247 Stones Farm, Cricklade Reserved Matters Application Consultee Comment Response
29.06.2026

Please find below the collective consultee comments made during the course of the Reserved Matters application to date.

- 247-VISI Rev - Visibility Splay Plan

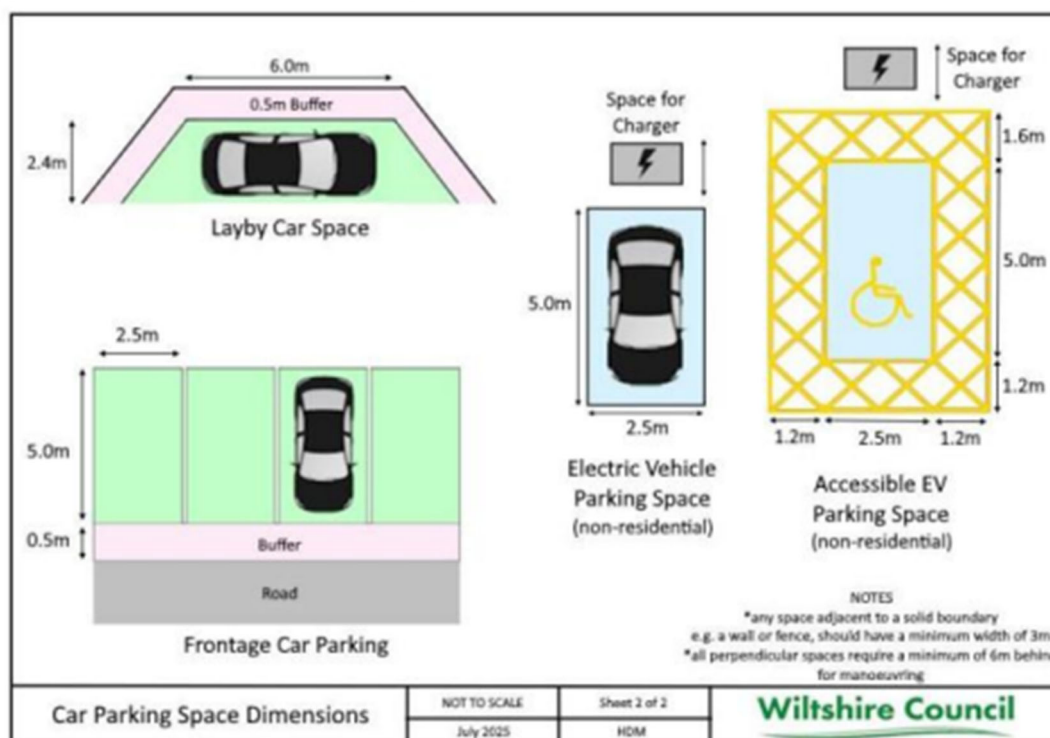
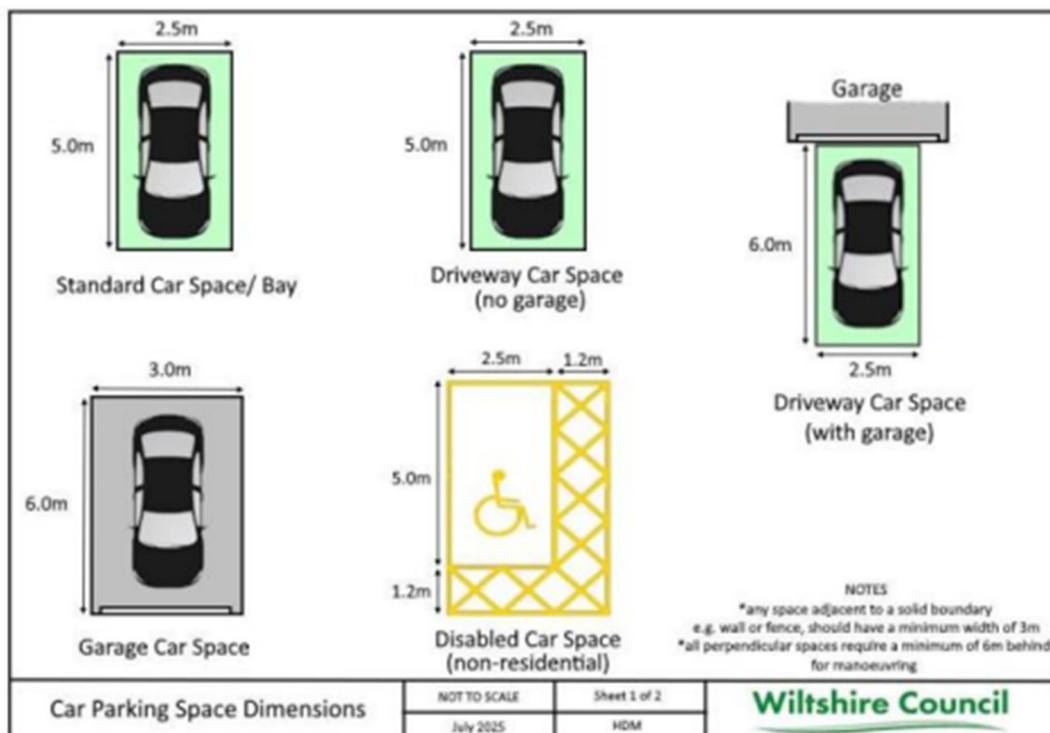
All visibility splays should conform with standard for a design speed of 20-mph and should provide splays measuring 2.4m by 25 m to the nearside carriageway edge. This should be achieved by all side roads and private drives. Regarding specific details in the plans:

- The visibility splay from the junction of the private road falls across the allocated parking for Plot 138
- Visibility splay to the right of private road across parking for Plot 120
- Tree to right of shared drive of Plots 106 & 107 within visibility splay
- Visibility to be shown as achievable from private shared drive 106/107
- Visibility splay from side road between Plots 41-51 across the frontage of Plot 51 and should be demonstrated that it can achieve 2.4 m by 25 m clear of obstruction
- Splays from Plots 14 & 15 across frontages and to be demonstrated or secured
- Splays to 2.4m by 25m at side road and Plot 92
- Splays across frontages of Plots 57 & 58
- Visibility splays across Plots 54, 55 and 56 and from the junction across Plot 56 required to demonstrate 2.4 m by 25 m
- Visibility from private drive at Plot 70

Drawings have been updated to accommodate comments. Please refer to drawing:

Assessed visibility splays from private / shared drives to suit a 20mph design speed being 2.4m x 17m (Manual for Streets). Further to this we have also included forward visibility splays and junction visibility splays from adoptable roads.
